**REQUEST**

Current Zoning: B-1(CD) (general business, conditional)  
Proposed Zoning: O-1(CD) (office, conditional)

Approximately 1.04 acres located at the northwest intersection of Carmel Road and Little Avenue, north of Pineville-Matthews Road, and east of Johnston Road.

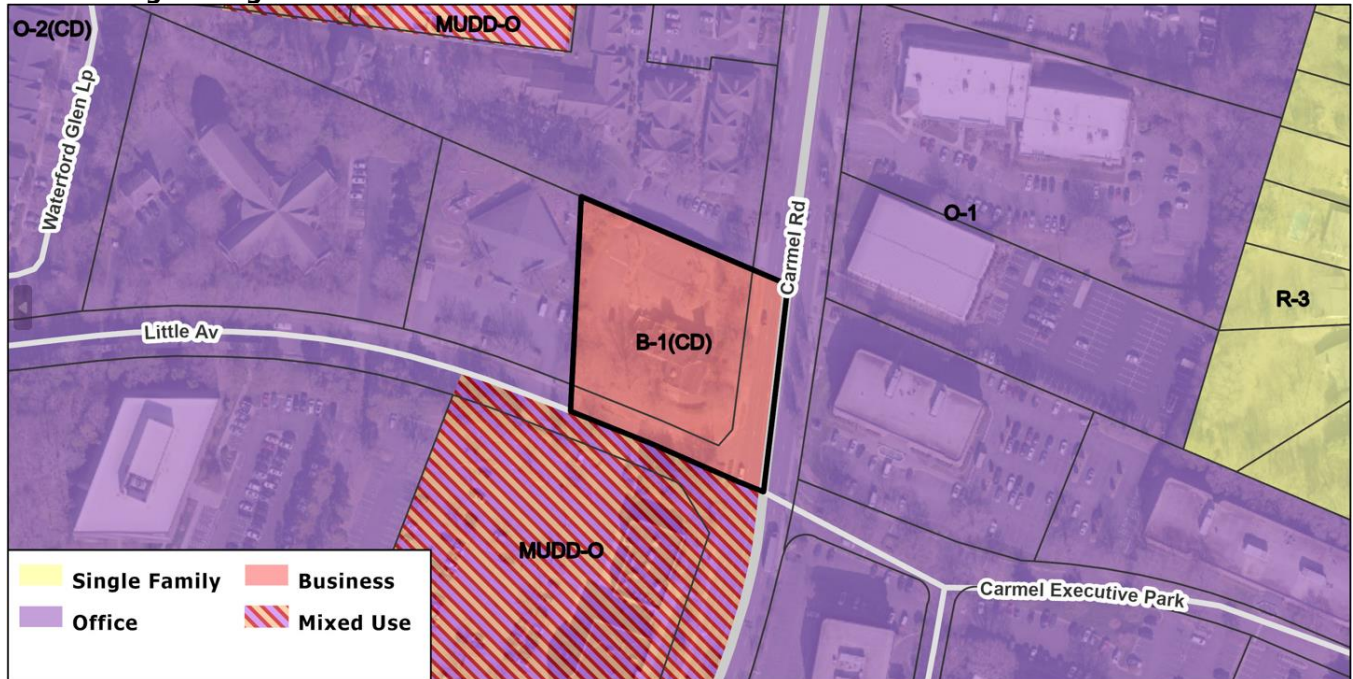
1. Incorporate architectural design standards as provided by Urban Design staff. **Addressed**
  - ~~Facades fronting streets shall include a combination of windows and operable doors for a minimum of 60% of each frontage elevation transparent glass between 2' and 10' on the first floor. Up to 20% of this requirement may be comprised of display windows. These display windows must maintain a minimum of 3'-0" clear depth between window and rear wall. Windows within this zone shall not be screened by film, decals, and other opaque material, glazing finishes or window treatments. The maximum sill height for required transparency shall not exceed 4'-0" above adjacent street sidewalk.~~

- ~~Multi-story buildings should have a minimum of 20% transparency on all upper stories.~~
2. Clarify if parking will be present under the building below grade or podium. If podium, the building should present ground floor active use along the public street fronts. **Addressed**

3. Add a note that no parking and maneuvering will be located between the building and street. **Addressed**

4. Adjust the site plan to show the back of curb and gutter along Carmel Rd at 33ft from the centerline to accommodate the Charlotte Streets Map with a roadway typical section of CLDSM 11.09 Major Thoroughfare. (Site plan currently shows 32 ft from centerline.) **Addressed**

5. Remove layers showing existing development or move the existing development information to a separate sheet. **Addressed**
6. Label and dimension the 12 ft multi-use path and 8 ft planting strip shown along Carmel Rd. and label and dimension the existing planting strip and sidewalk along Little Ave. **Addressed**
7. Add a note committing to the construction of the 8 ft planting strip and 12 ft multiuse path. **Addressed**
8. Add a note committing to the provision of the 14 ft Class C buffer that is shown on the site plan. **Addressed**

9. Label and dimension the curb and gutter from the centerline of each road on the site plan. **Addressed**
